DEPARTMENT OF THE ARMY

SUBJECT: Civil Action 80-73699 - Consent Decree, BASF Wyandotte Corporation (BWC), Riverview, Michigan, Site Modification Program

Chronological Record of Events
Related to BASF Wyandotte Corp.
Riverview Site Seepage Problem.

SKETCH I-B

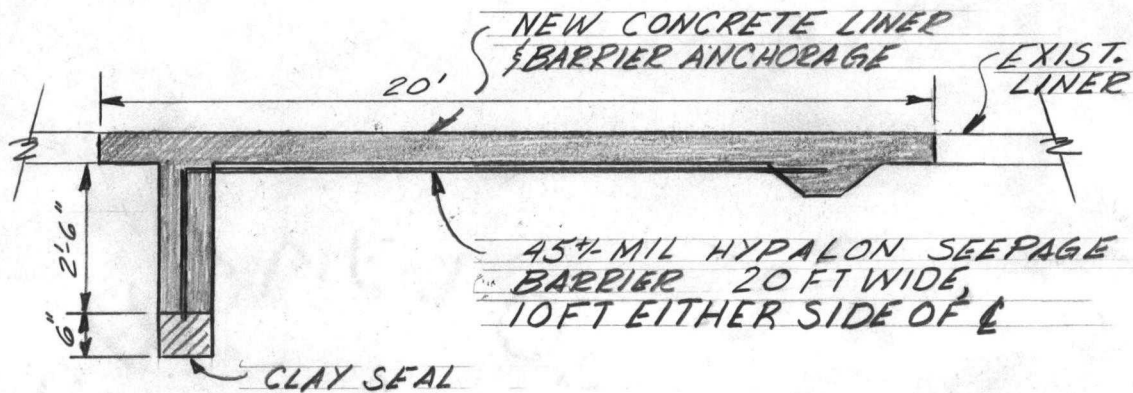
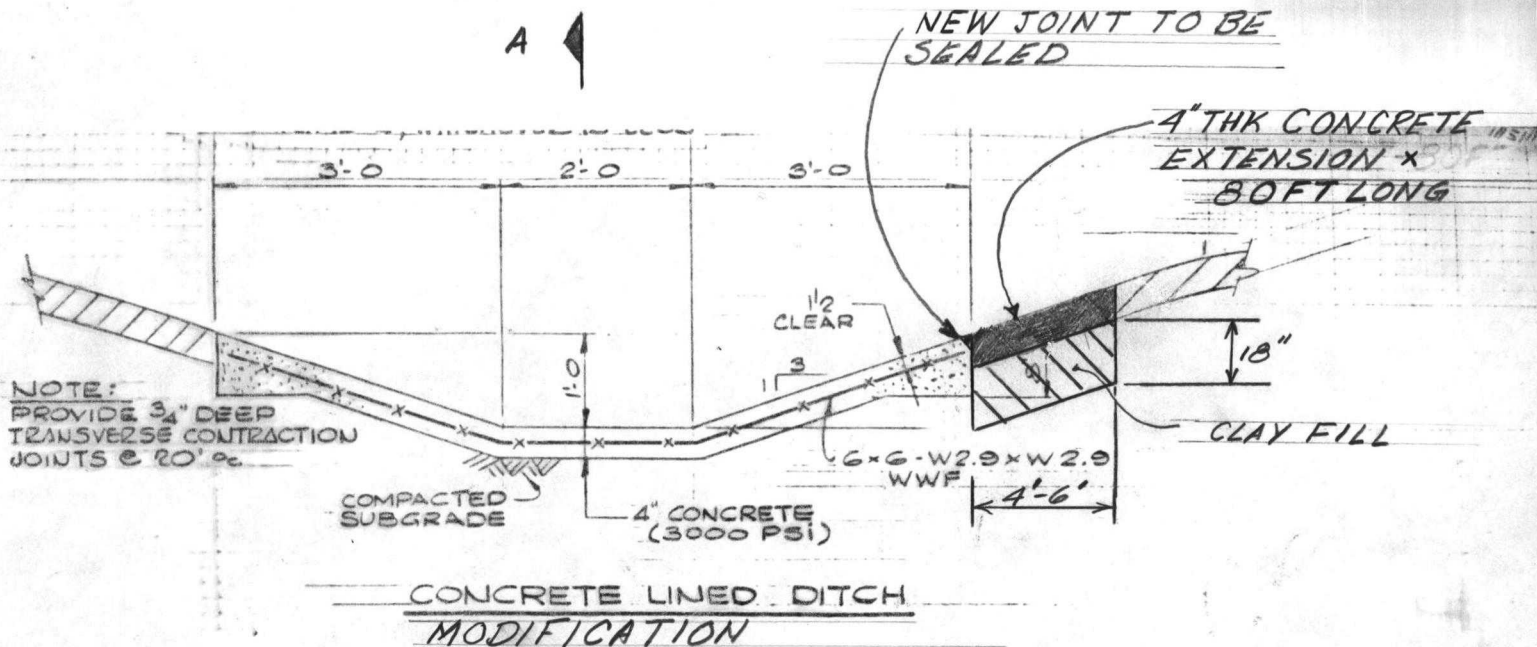
- a) In the area where seepage liquid is pooling along the north edge of the ditch an 80 ft. strip, approximately 40 ft. either side of Station 5, 2 feet deep and cut back along the new north slope to a point approximately 6 inches below level grade (about 4 to 6 feet wide) will be excavated and filled with 18 inches of clay. A visqueen barrier will be laid on top of the clay and 4 inches of concrete poured over the visqueen. Construction joints will be sealed to prevent leakage. See the attached sketches I-A & B.

- b) To prevent seepage from discharging into the Trenton Channel from the center ditch BWC is planning to rip out 20 ft. of the concrete ditch liner on the property, or west, side of the fence. A hypolon liner (45+/-mil) will be laid with the downstream end in a 3 ft. deep by 3" or 4" wide trench and the upstream end anchored to the bottom of the new concrete liner. The trench will be filled with 6 inches of clay topped with 2'-6" of concrete with the hypolon liner centered in the filler. The trench will extend across perpendicular to the ditch, 10 ft. either side of the ditch center line. See the attached sketches I-A & B.

10. October 24 thru 26 -- No work done on center ditch modifications due to wet conditions. Seepage at ditch continues.
11. October 30, 1984 -- BWC has placed the clay and poured the concrete liner extension in the 80 ft. section along the north side of the center ditch. A 20 ft. section of ditch liner near the east fence line has been removed. A 3" to 4" trench will be cut for the hypolon liner. New rip rap is being placed off the end of the ditch preparatory to constructing the 10 Ft. ditch extension. Refer to attached Sketches I-A & I-B.

SKETCH II-B

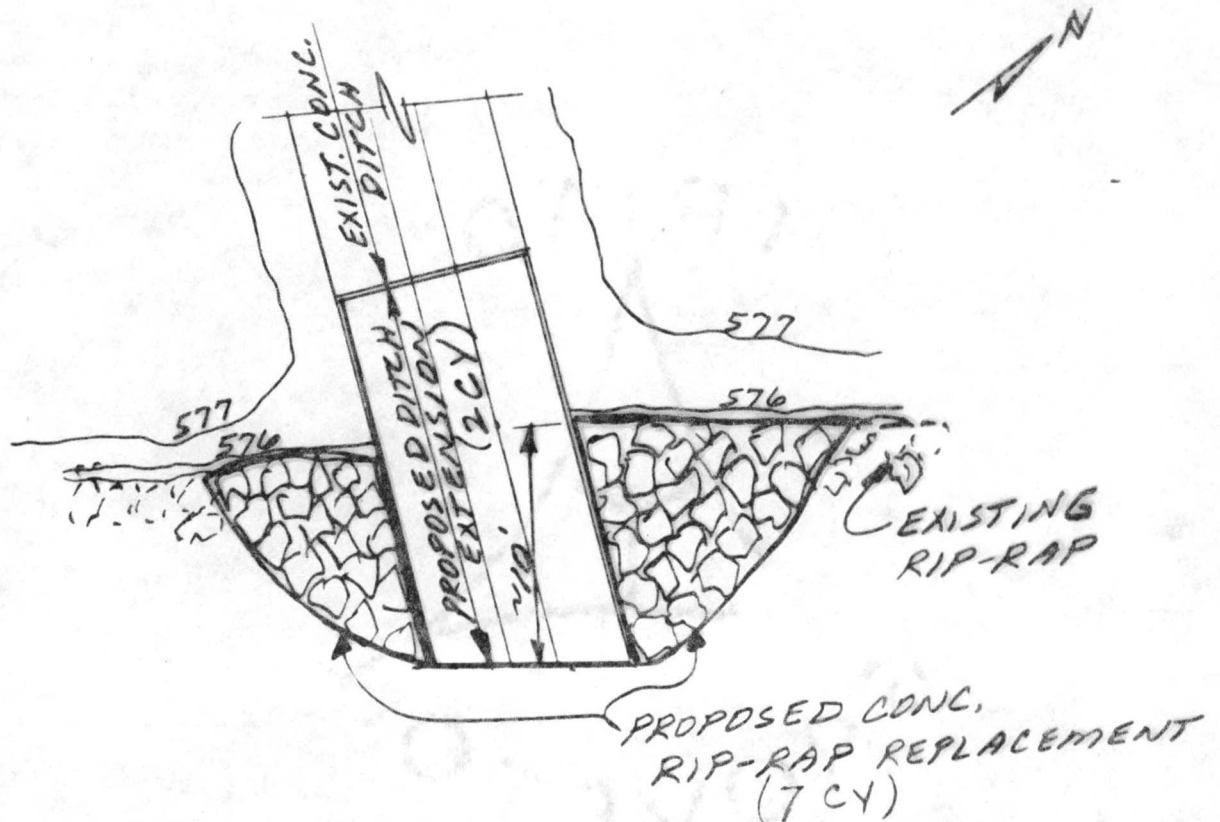
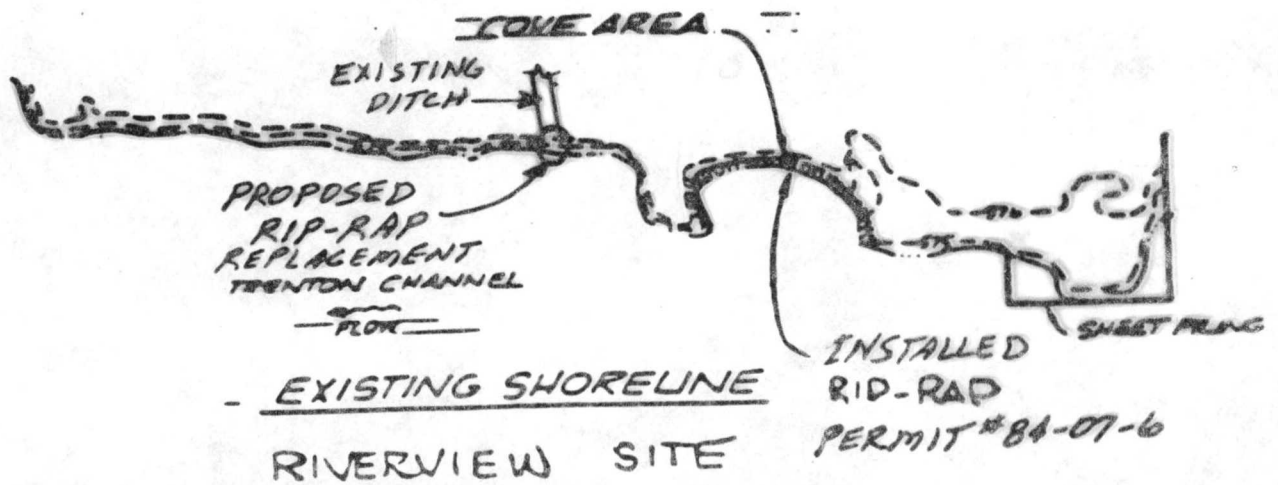
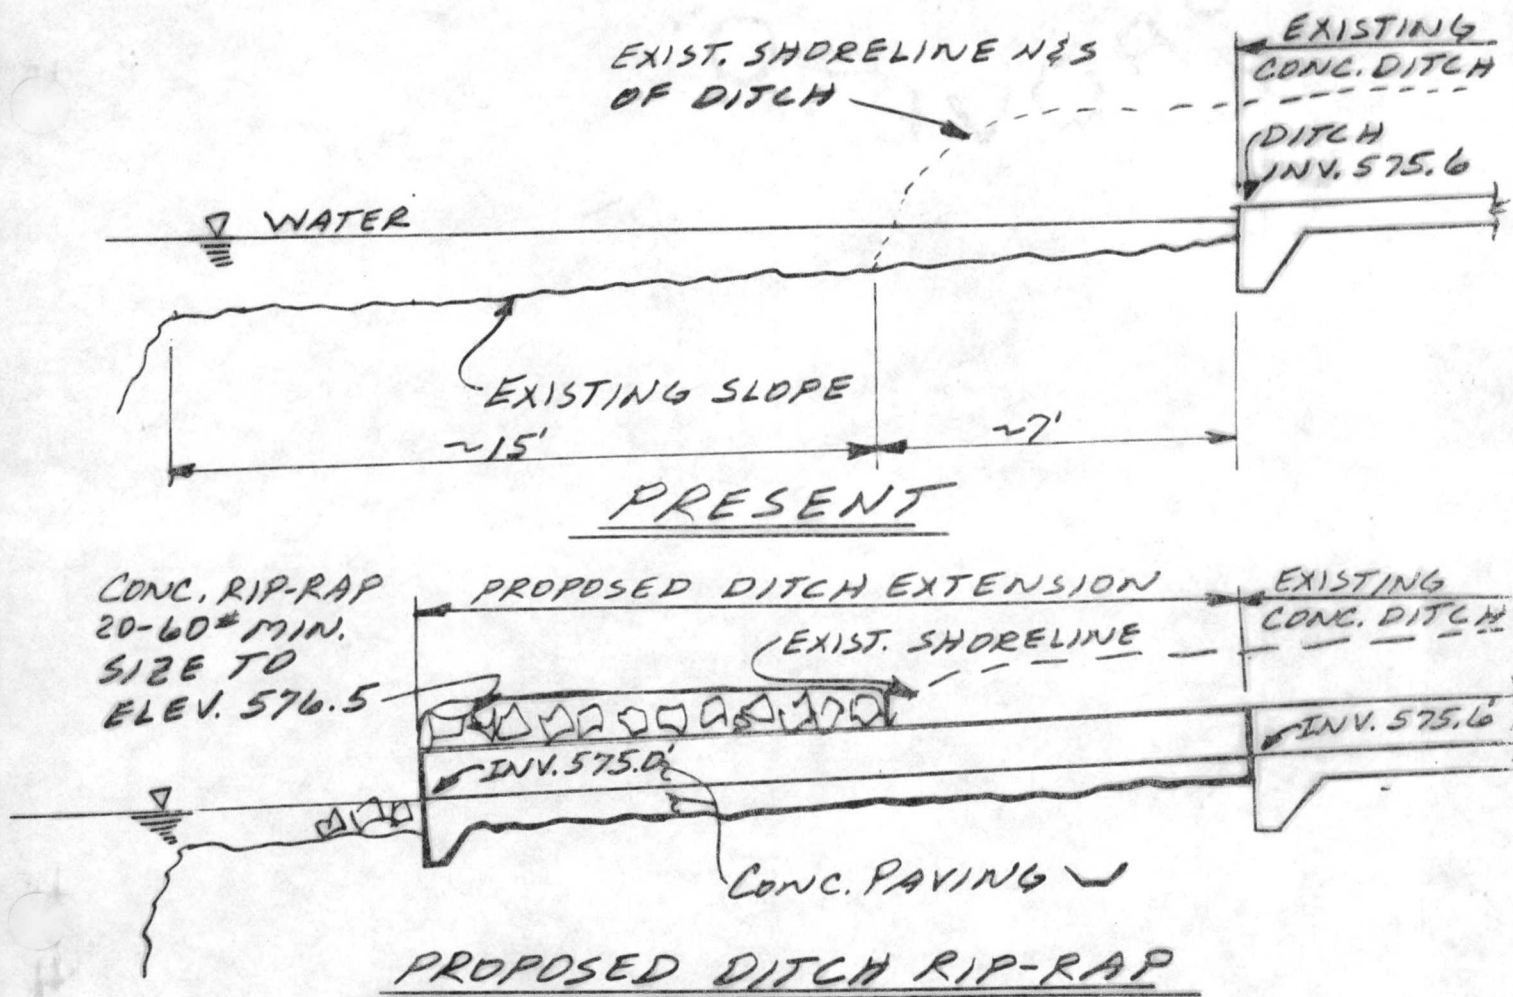
- c) At the discharge end of the ditch, to eliminate the erosion of the channel bottom caused by the ditch outfall during rain periods, BWC is going to extend the concrete surface 10 feet past the current shore line and replace the rip rap that was disturbed or lost during construction. An amendment to the MDNR, and Department of the Army permits will be required for this work. See the attached sketches II-A & B.

7. October 17, 1984 -- The amended Department of the Army Permit 84-07-06 was delivered to BWC. Refer to attached Sketches II-A & B. MDNR approval is also required and BWC is following up on it.
